ADDENDUM NO. 1

Reference: Fire Suppression System Replacement – West Jordan AASF
Utah National Guard – West Jordan, Utah
DFCM Project No. 09022480

Project: 09022480 – AASF South Hangar Fire Protection Upgrade

Subject: Addendum #1

FP-1

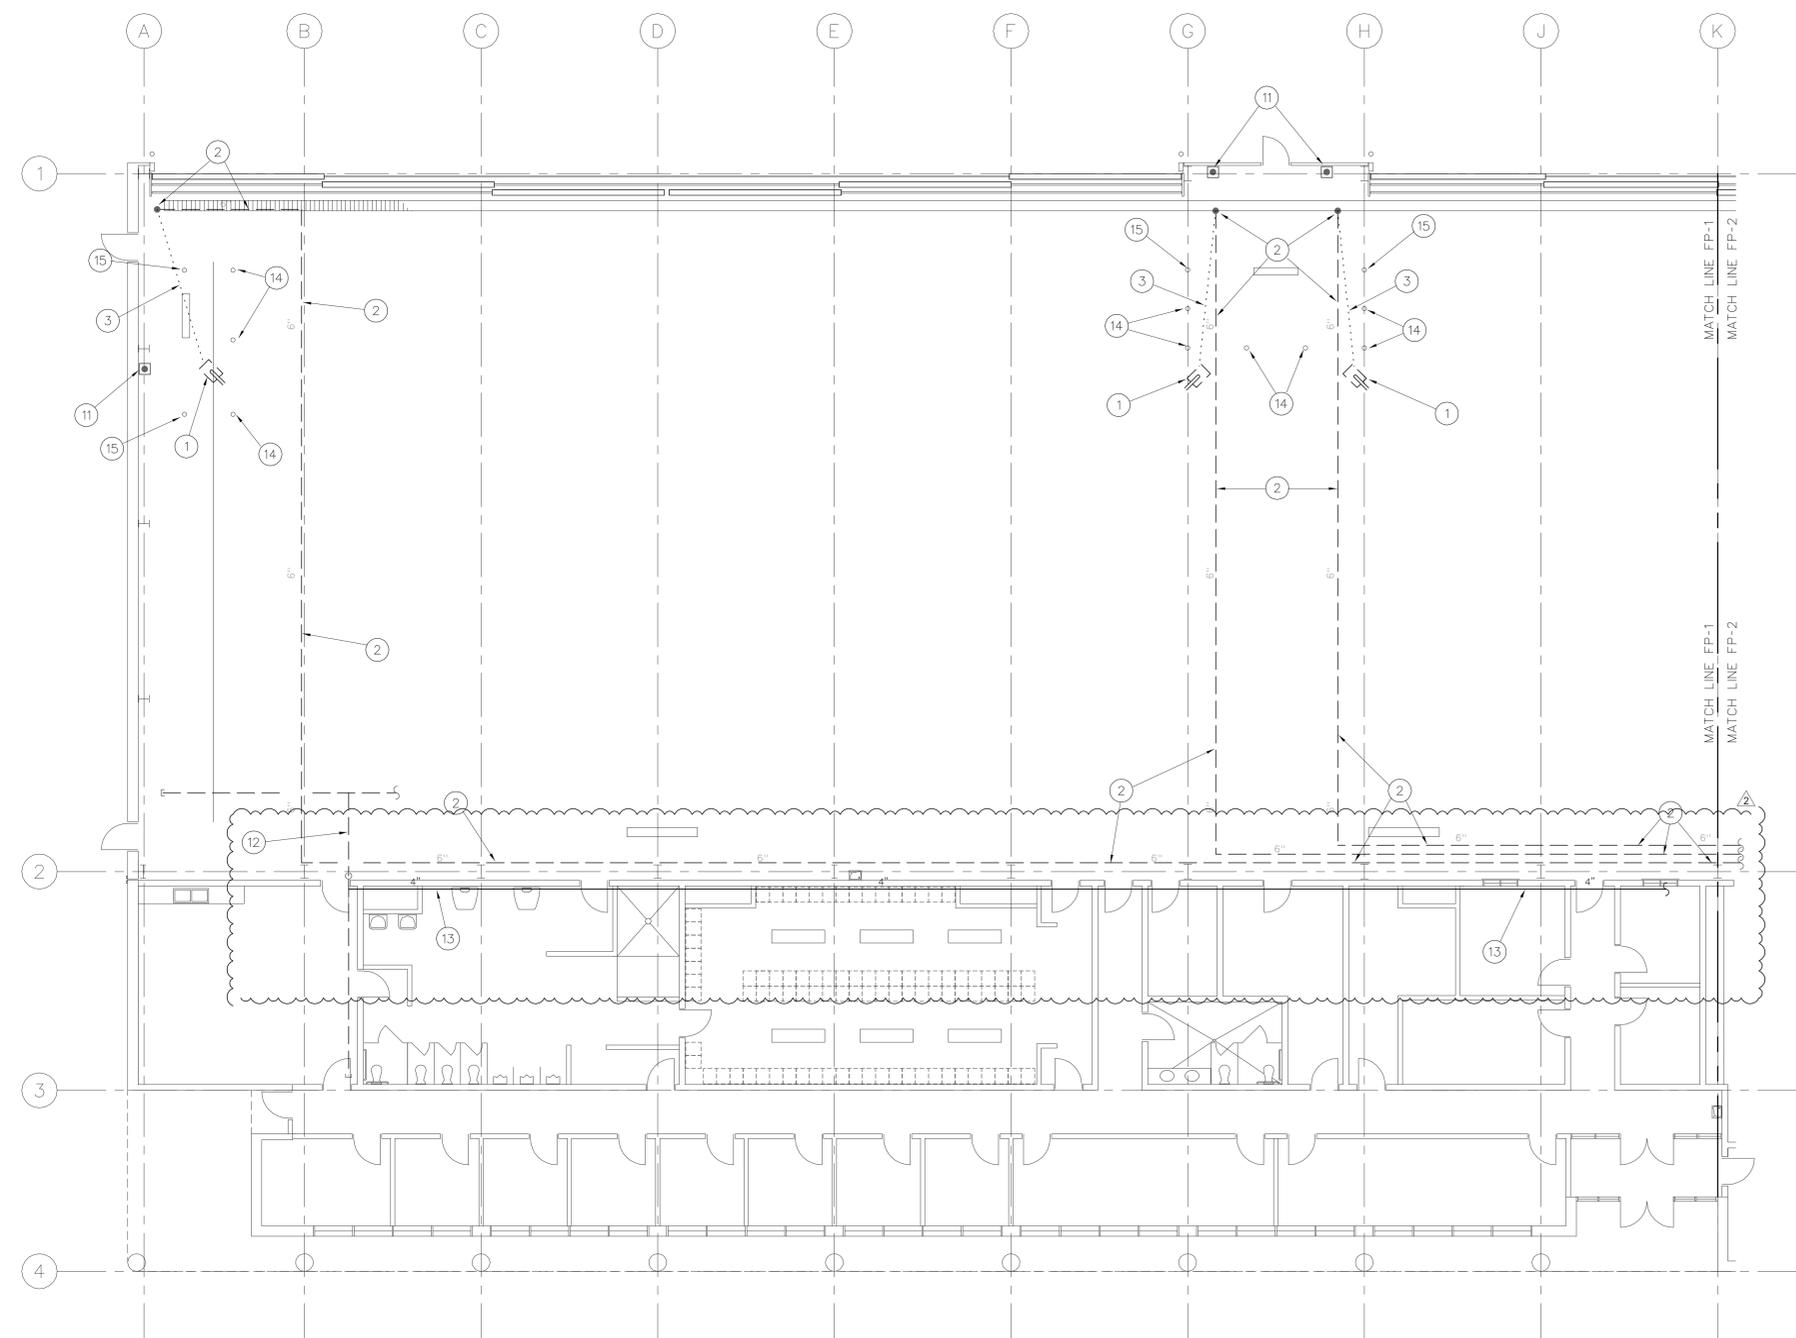
I. Drawing Revisions Sheet FP1:

1. Edited key note 2 to indicate that existing horizontal 6” piping for AFFF monitors could be abandoned in place.
2. Added Bid Alternate #1 to provide a separate price for demolition of the existing horizontal 6” piping for AFFF monitors.

3. Added key note 12 to require demolition of existing 4” feed main from north side of overhead fire sprinkler grid to support spaces.
4. Added key note 13 to require installation of a new 4” feed main from the center of the hangar to the north end of the piping grid for the support spaces.

5. Added key note 14 to clarify which pipe bollards are required to be demolished.
6. Added key note 15 to clarify which pipe bollards may remain.
7. Edited key notes 1 and 3 to indicate that painting of the floor where new concrete is installed will be provided by the owner.

8. Edited key note 0 to eliminate the requirement to flush and inspect the bladder of the foam tank that will be abandoned in place.

FP-2

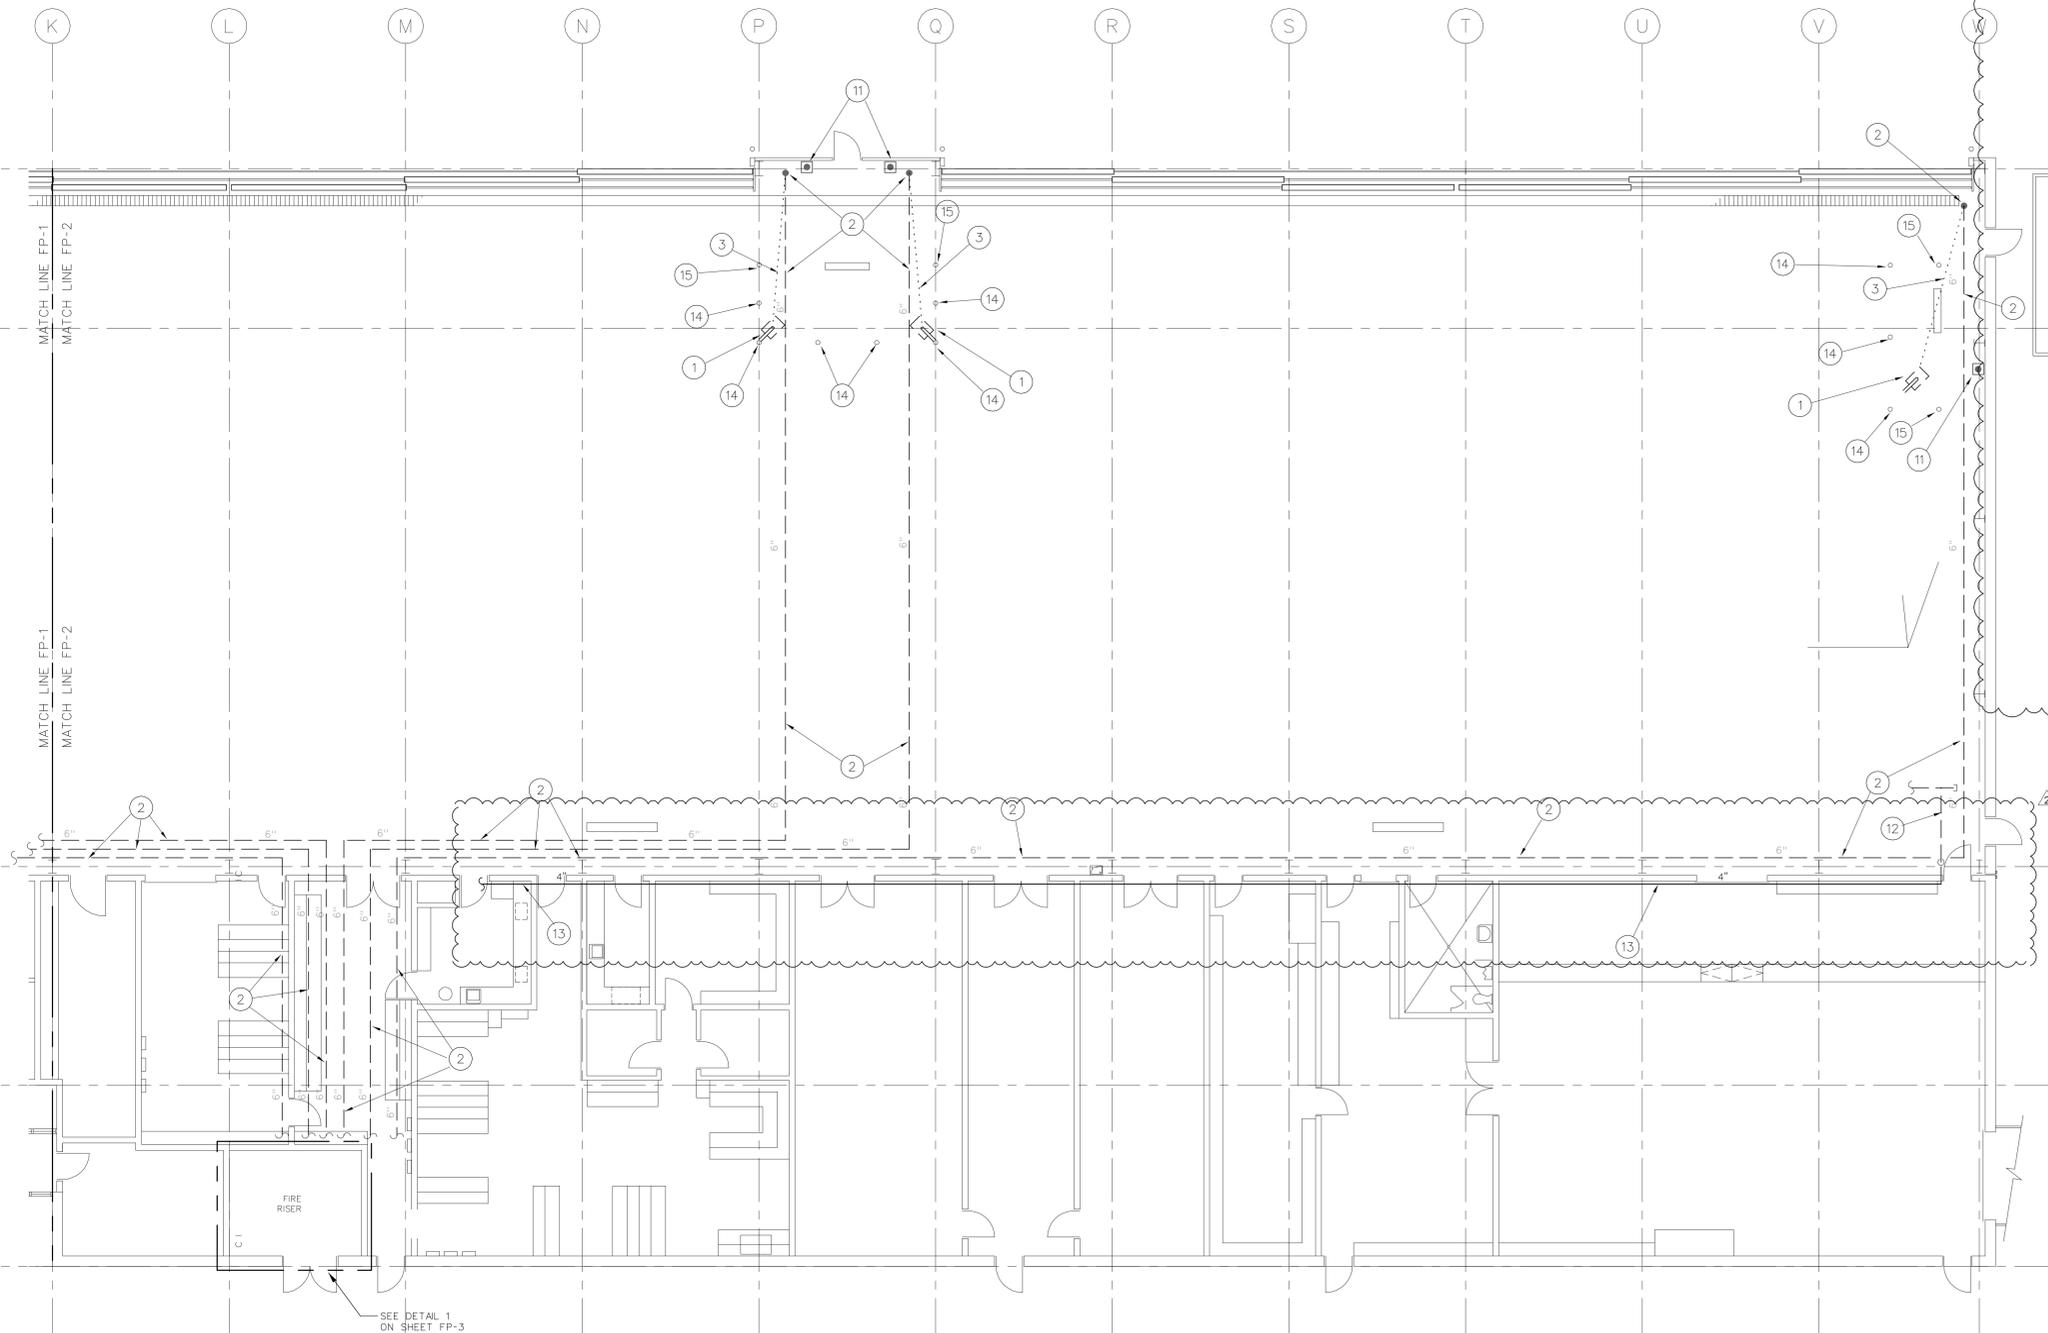
II. Drawing Revisions Sheet FP2

1. Edited key note 2 to indicate that existing horizontal 6” piping for AFFF monitors could be abandoned in place.

2. Added Bid Alternate #1 to provide a separate price for demolition of the existing horizontal 6” piping for AFFF monitors.
3. Added key note 12 to require demolition of existing 4” feed main from south side of overhead fire sprinkler grid to support spaces.
4. Added key note 13 to require installation of a new 4” feed main from the center of the hangar to the south end of the piping grid for the support spaces.
5. Added key note 14 to clarify which pipe bollards are required to be demolished.
6. Added key note 15 to clarify which pipe bollards may remain.
7. Edited key notes 1 and 3 to indicate that painting of the floor where new concrete is installed will be provided by the owner.
8. Edited key note 9 to eliminate the requirement to flush and inspect the bladder of the foam tank that will be abandoned in place.

FP-3

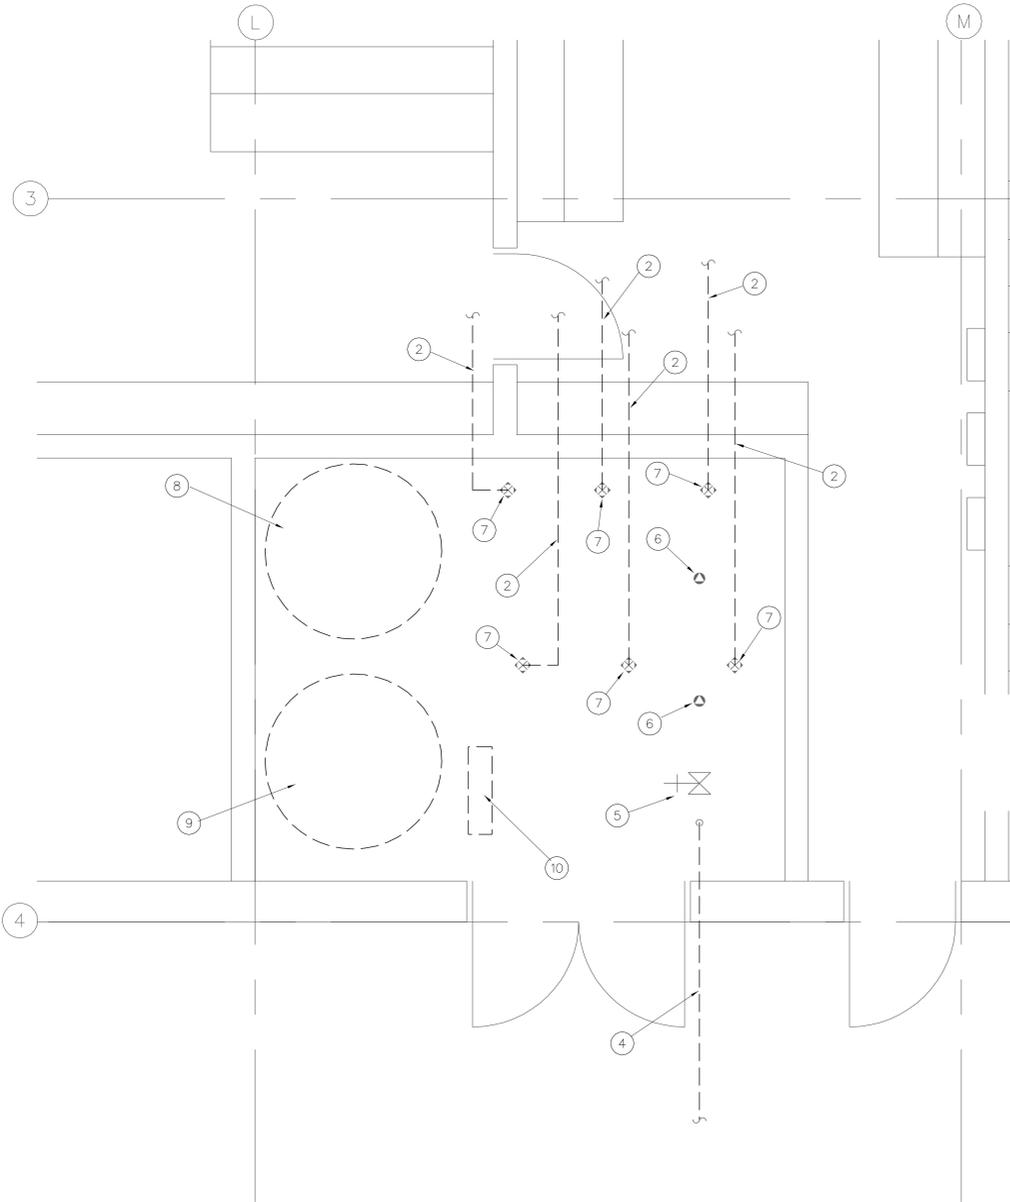
III. Drawing Revisions Sheet FP3

1. Edited key note 9 to eliminate the requirement to flush and inspect the bladder of the foam tank that will be abandoned in place

FP-4

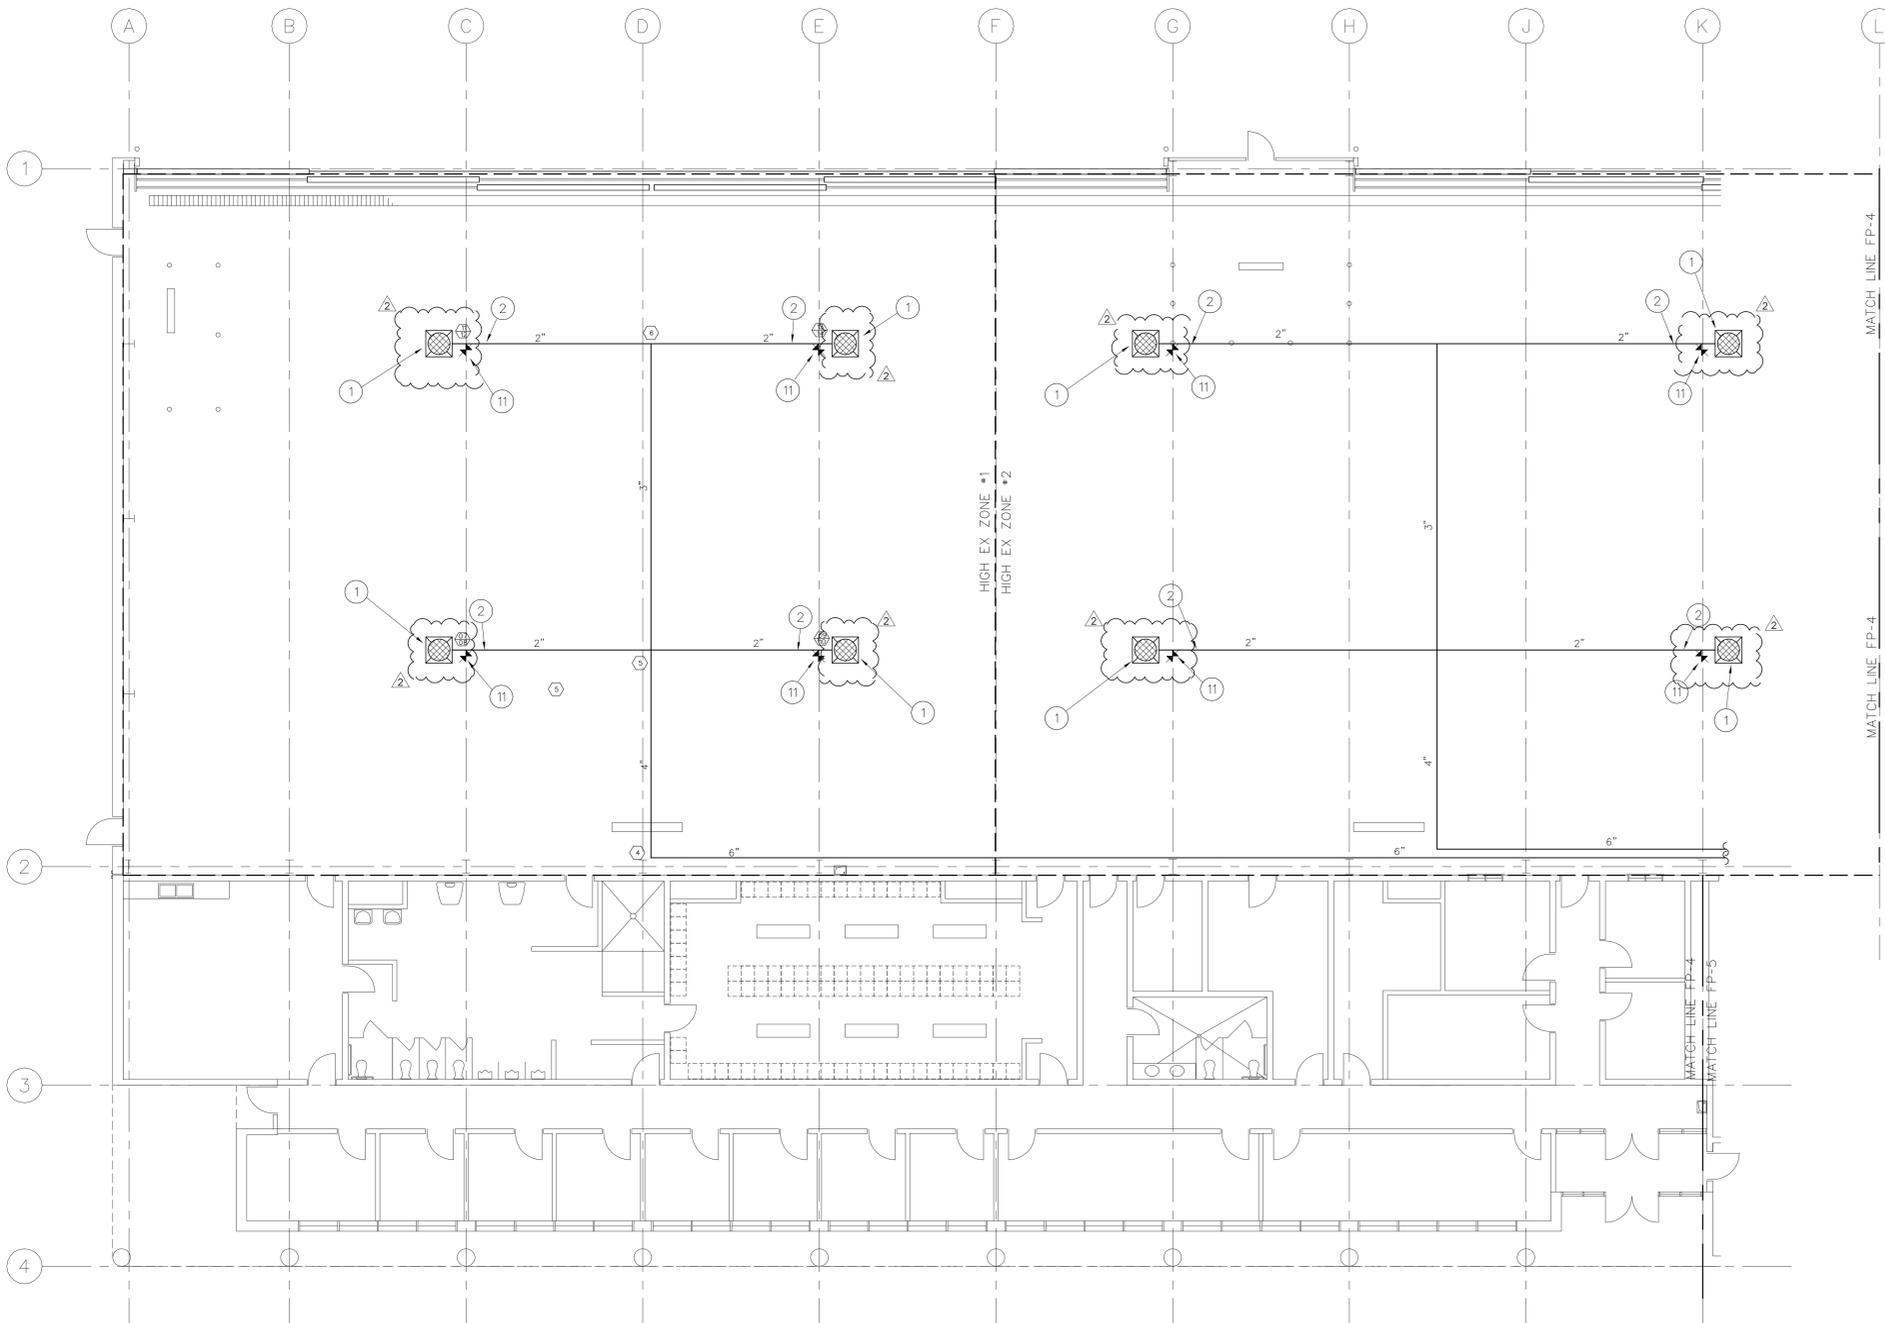
IV. Drawing Revisions Sheet FP4

1. Relocated high expansion foam generators to better coordinate with aircraft locations.
2. Edited key note 1 to specify a minimum mounting height of 31’-0” to the bottom of the foam generator as required to avoid conflicts with bridge crane.
